Economic Development & Planning Committee

REPORT TO ECONOMIC DEVELOPMENT PLANNING COMMITTEE - PUBLIC MEETING - 4 DECEMBER 2012

28 November 2012
REPORT TO THE ECONOMIC DEVELOPENT PLANNING COMMITTEE - PUBLIC MEETING – 04 DECEMBER 2012

2012-191-12
PROPOSED OFFICIAL PLAN AMENDMENT,
ZONING BY-LAW AMENDMENT AND
PLAN OF SUBDIVISION
550 KING STREET WEST
CITY OF BROCKVILLE

SCHEDULE "B" Report 2012-191-12

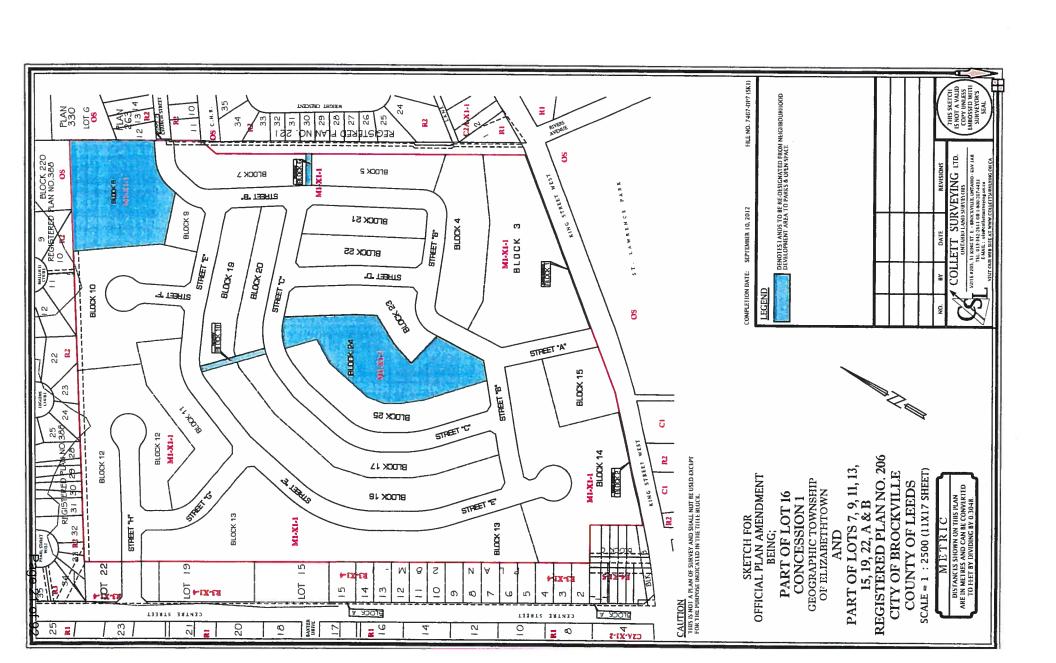
As a part of the subdivision review process, CRCA staff reviewed the Evaluation of Significant Woodland (Muncaster/Bowfin, 2012). Staff found the report's methodology for assessing the woodlands on the subject property to be appropriate and the findings and recommendations to be satisfactory. The consultants identify, on Figure 5 (pg 28) of the report, the remaining forest area patches once removal has occurred on the subject property and include recommendations to ensure proper protection. Staff recommend that the retained woodland patches be displayed and labeled on the draft plan.

Staff of the Cataraqui Region Conservation Authority recommend deferral of Application for Official Plan Amendment D09-001, Application for Zoning By-law Amendment D14-158 and Application for Draft Plan of Subdivision Approval 08T-12501 until such time that a preliminary stormwater management report is submitted to demonstrate that on-site, enhanced quality control will be provided. Staff also recommend that a revised draft plan, incorporating the woodland comments above, be submitted.
